Technical Service Bulletin

MODEL(S) T300/T300e Walk-Behind Scrubbers
AFFECTED:

SUBJECT: Reduced battery run-time and/or BDI fails to display a full charge after a complete charge cycle.

9017921 Jumper Kit Contents

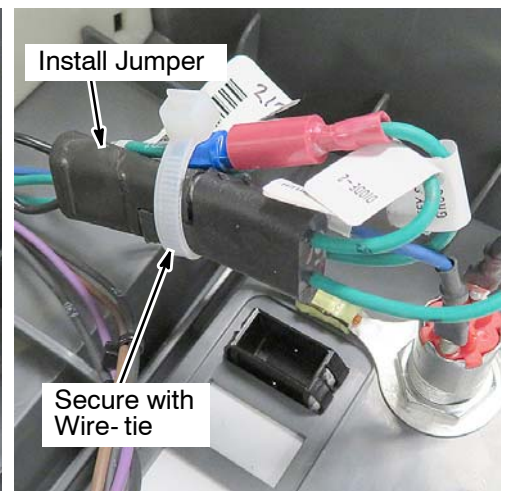
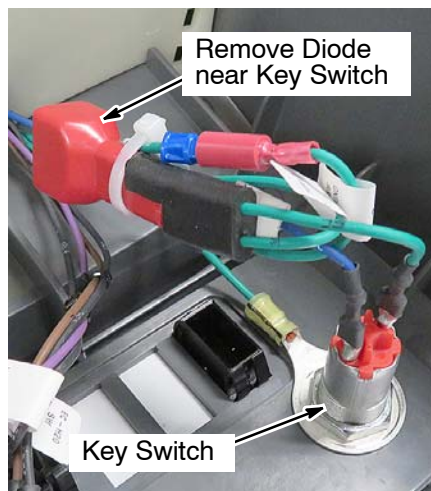
Root Cause: A diode was recently added to the wire harness to prevent potential control board failure if battery terminal connection is accidentally reversed. Reports claim the addition of the diode has caused a small voltage drop affecting the firmware to act as if the batteries are at a lower voltage.

PURPOSE: To repair the above issue, the diode must be removed and replaced with Jumper Kit 9017921 as shown below. As an alternative option to repair issue, the diode connector plug can be cut from the wire harness and replaced with a spade terminal also shown below.

Install Jumper Kit to repair issue:

* The kit contents will include either a wire harness jumper or a plug connector jumper as shown above. Both serve the same purpose.
